To: Ms. Debra Rossi, RPM (USEPA Region III)

From: Theresa Miller, PG, LSP (Golder) and Michele Ruth, PE (RAI)

Date: June 1, 2018

RE: Response to Comments on Work Plan for Additional Investigation
Army Creek Landfill, New Castle County, Delaware

Figure 2.
Existing and Proposed Monitoring Network for ACL Western Lobe Investigation

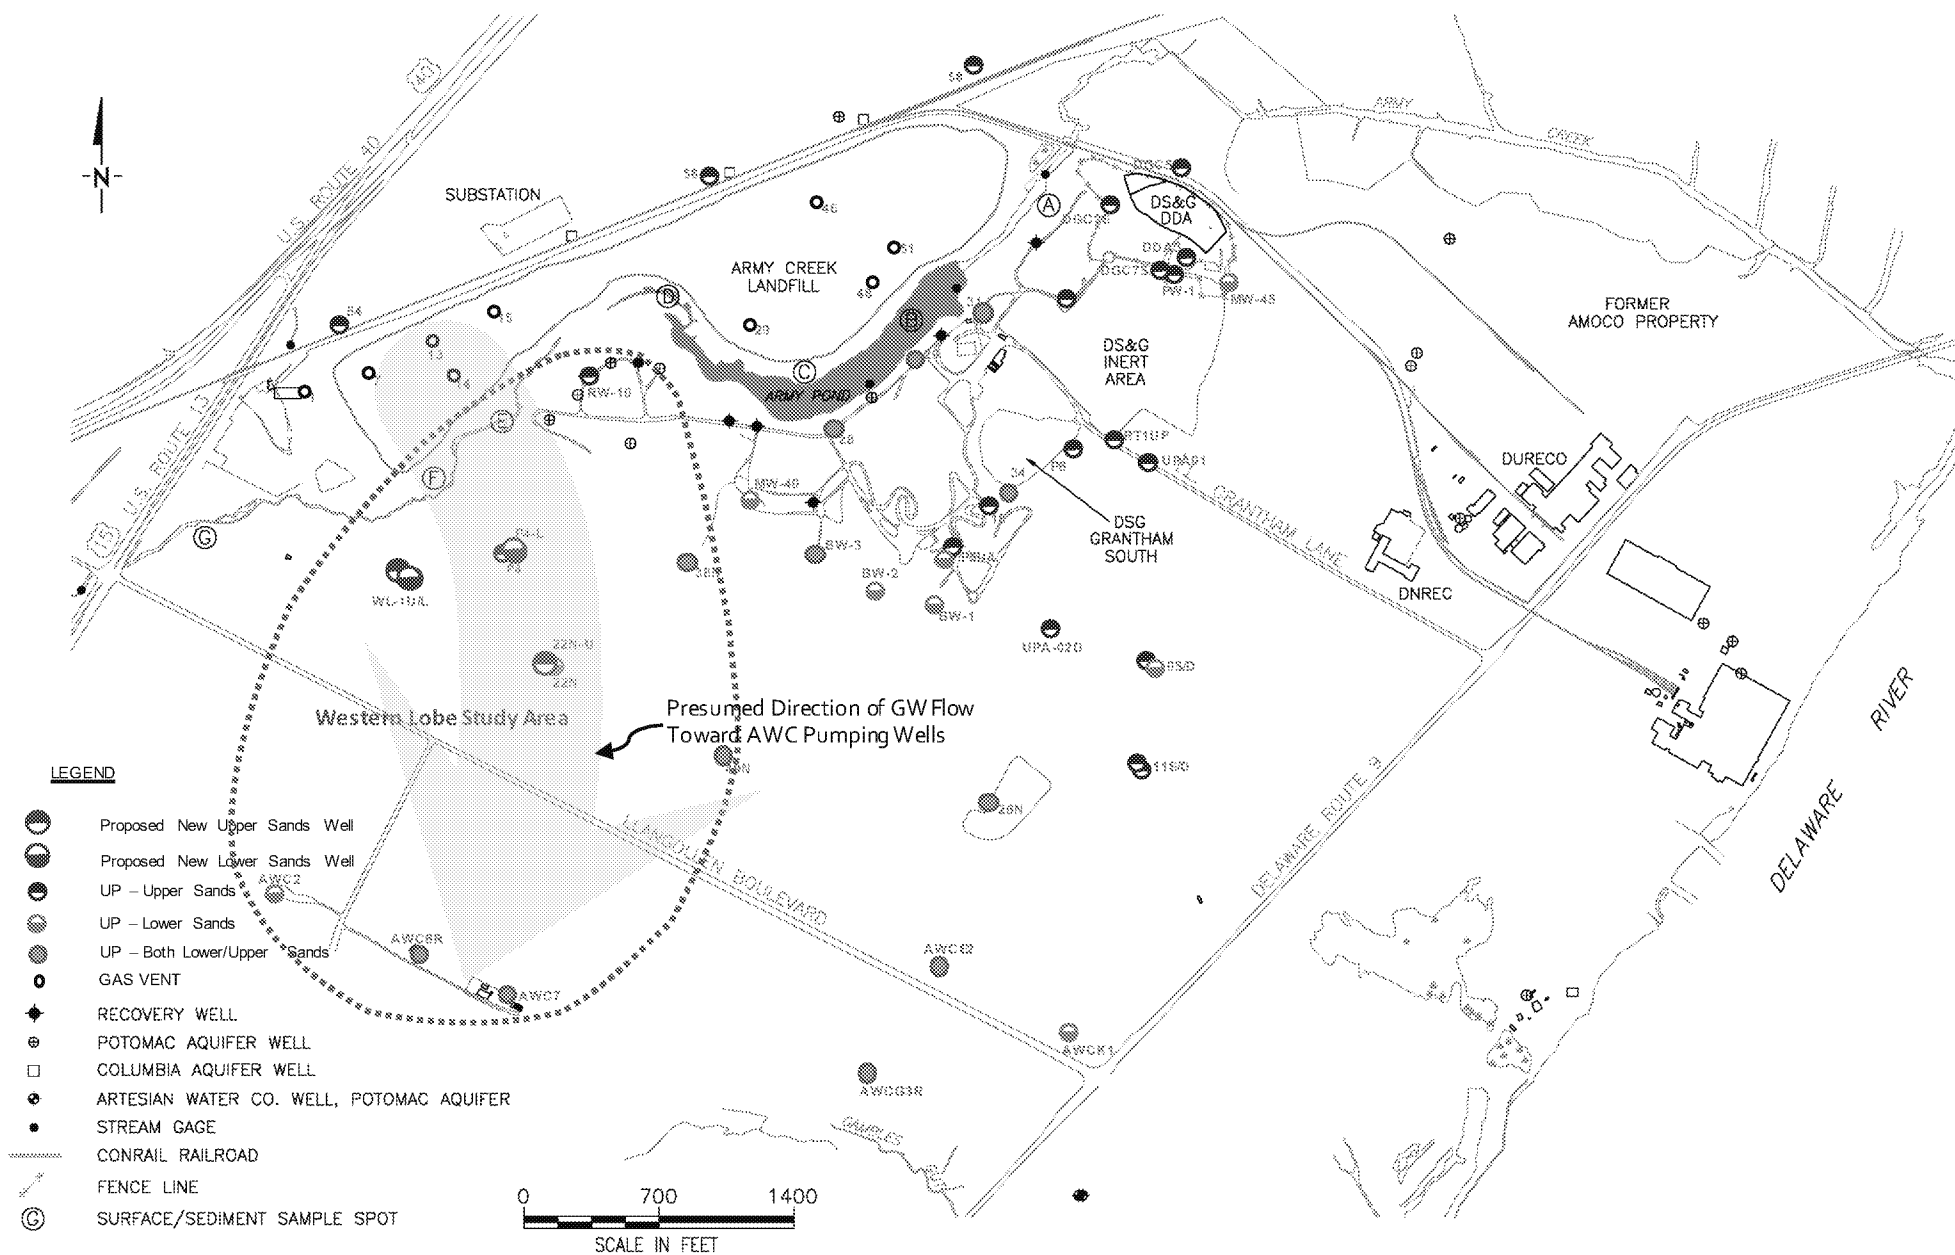
USEPA/DNREC Comment 13. Table 1: Is monitoring well 38N the same well as 38 depicted on Figure 2? Please clarify.

USEPA/DNREC Comment 15. Figures 2 and 4: The gas vents are represented by an assortment of circles, ovals, rings and squares. The same symbol should be used to represent all of the gas vents and the symbol should match the corresponding symbol in the legend.

Yes. The well designation has been changed to 38N on Figure 2. The attached Figure 2 will be included in the revised Work Plan.

As requested, Figures 2 and 4 have been revised; Figure 4 has been re-designated as Figure 6. The attached Figures 2 and 6 will be included in the revised Work Plan.

Figure 6.
Locations of Proposed Wells to be included in ACL's PFAS Monitoring Program

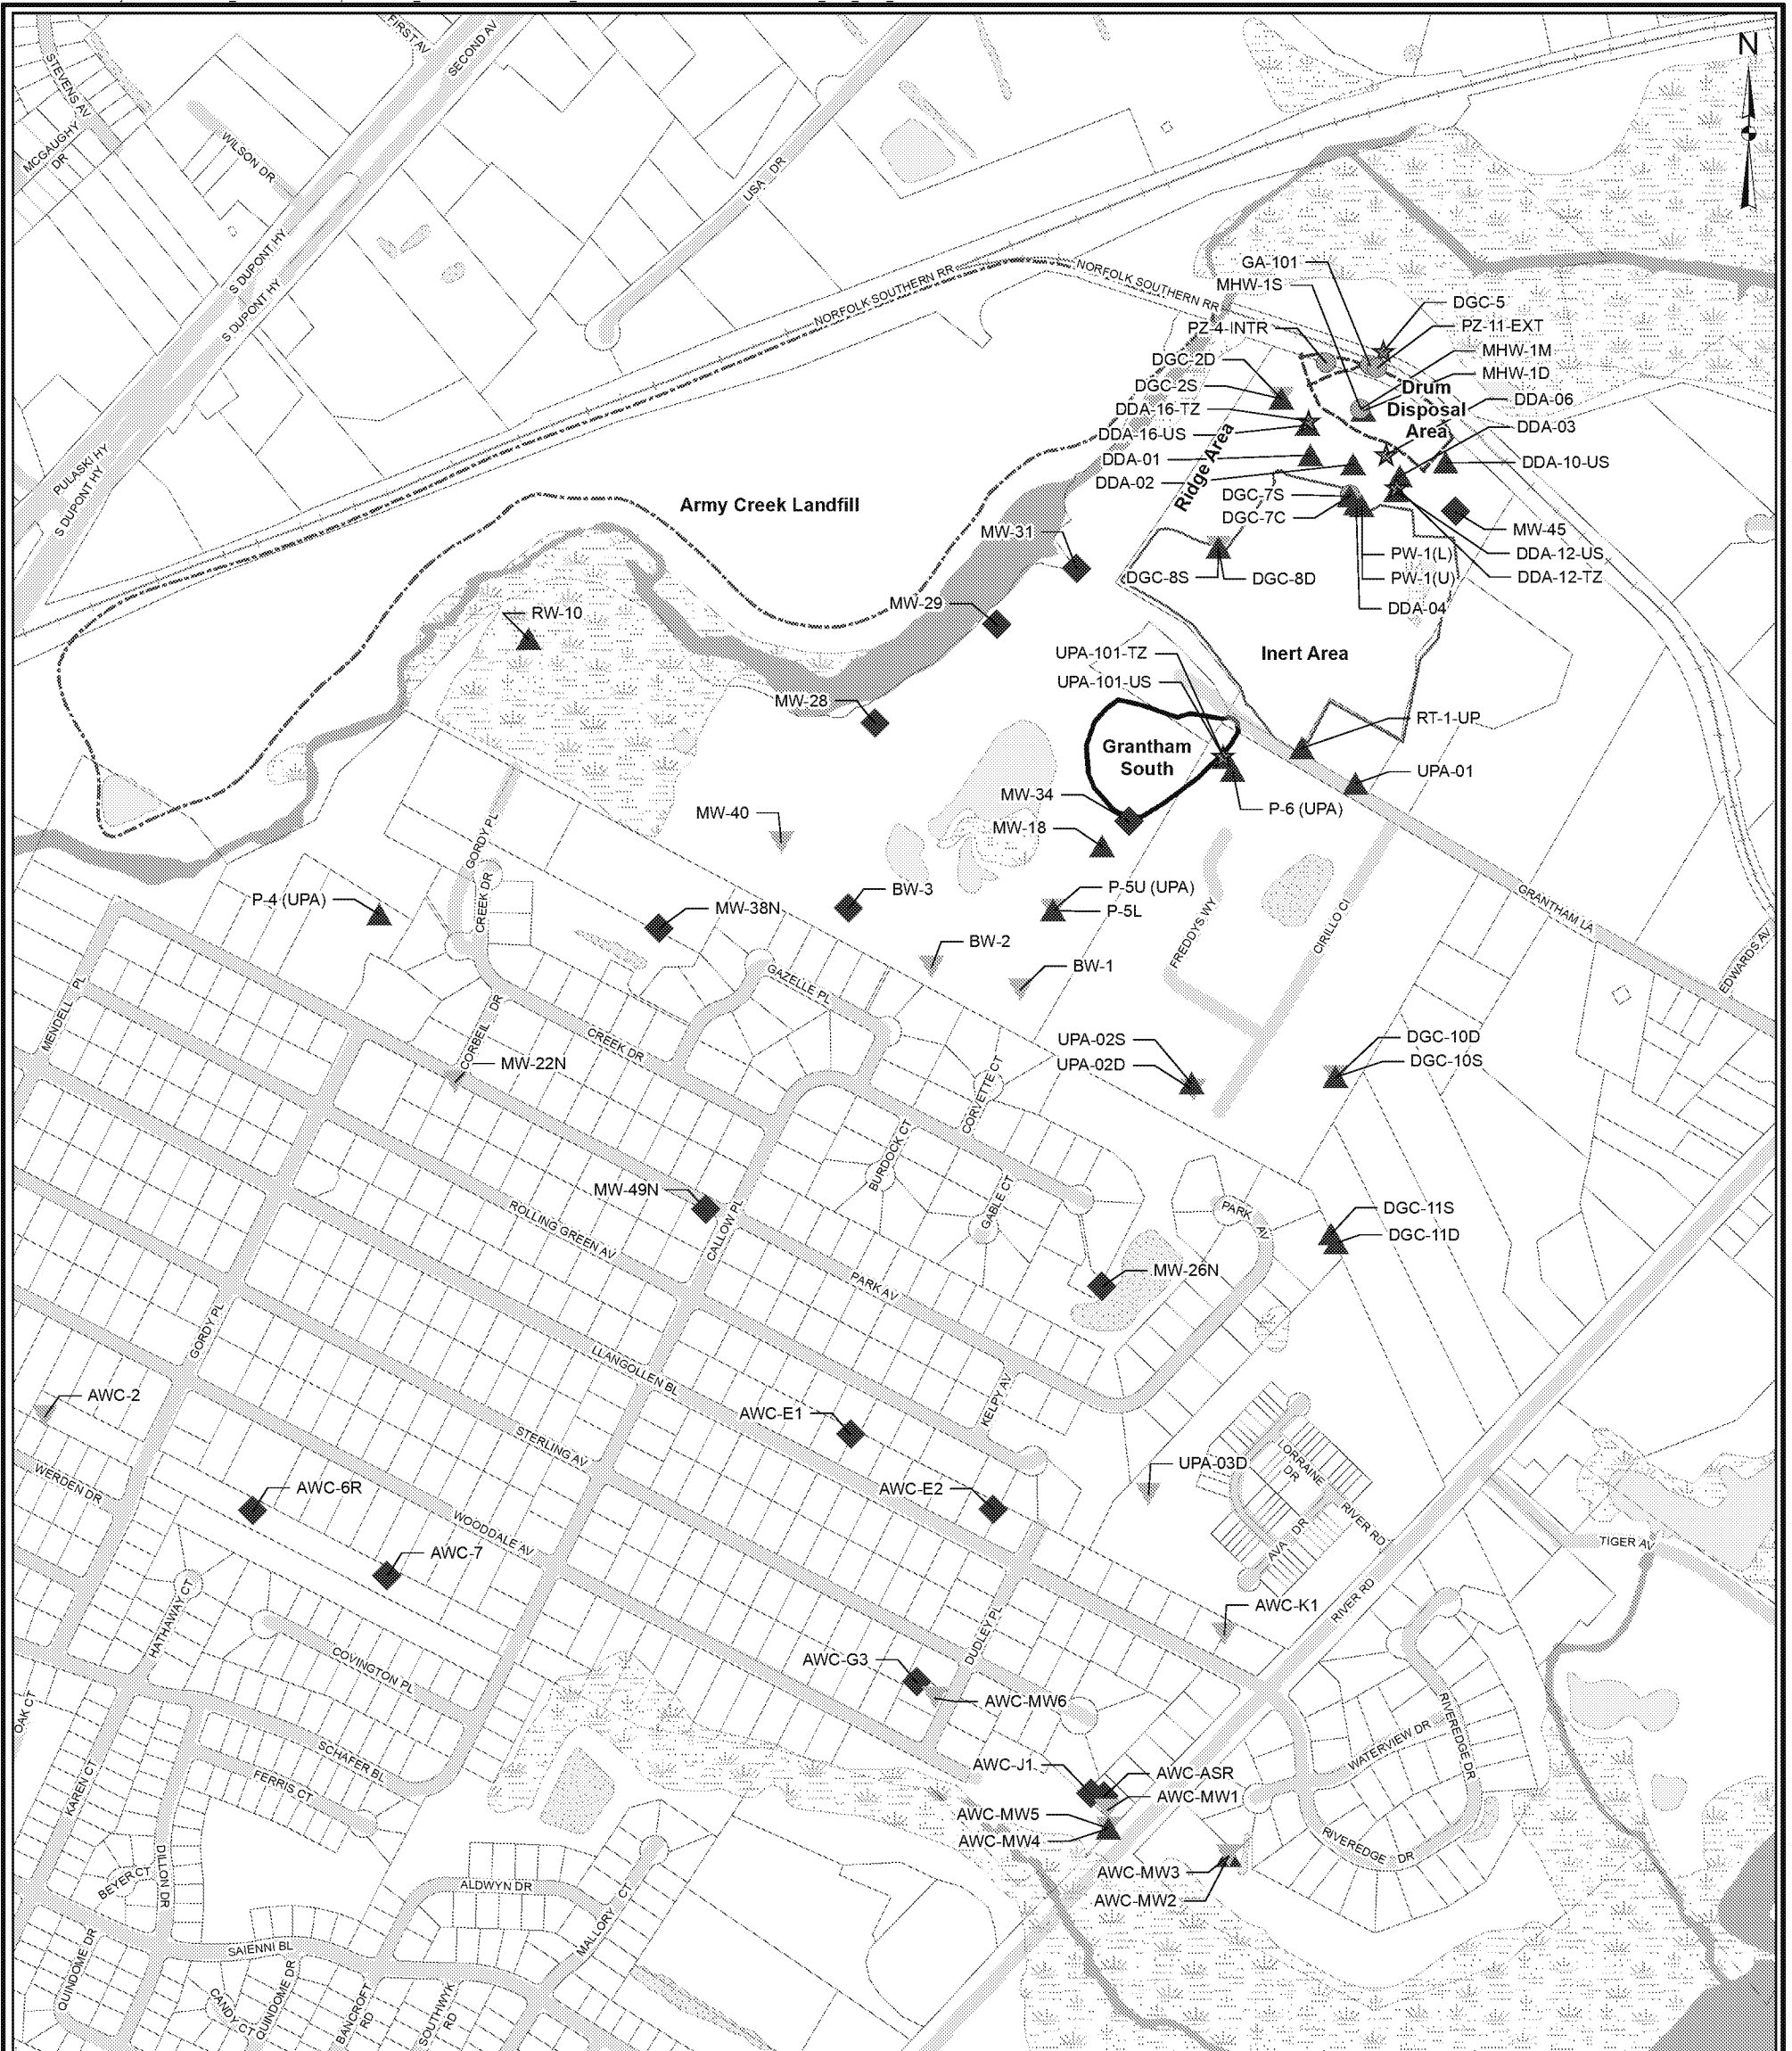
USEPA/DNREC Comment 6. Approaches and Methodologies, Western Lobe Study Area, first bullet: Artesian wells AWC-2, AWC-6R and AWC-7 are important data points at the south end of the study area as implied in the text of the Work Plan. However, the wells are not identified as sampling points in Table 1 and Figure 4. These wells should be sampled. If they will be sampled under another program (e.g., by Artesian), this information should be provided in the Work Plan, as well as a description of the sampling/analytical methods for the program and an assessment of the data comparability.

As requested, Table 1 and Figure 4 (now designated Figure 6) have been revised to include the locations for wells AWC-2, AWC-6R, and AWC-7. We have also included AWC-G3R in the revised table and figure, which are attached and will be included in the revised Work Plan.
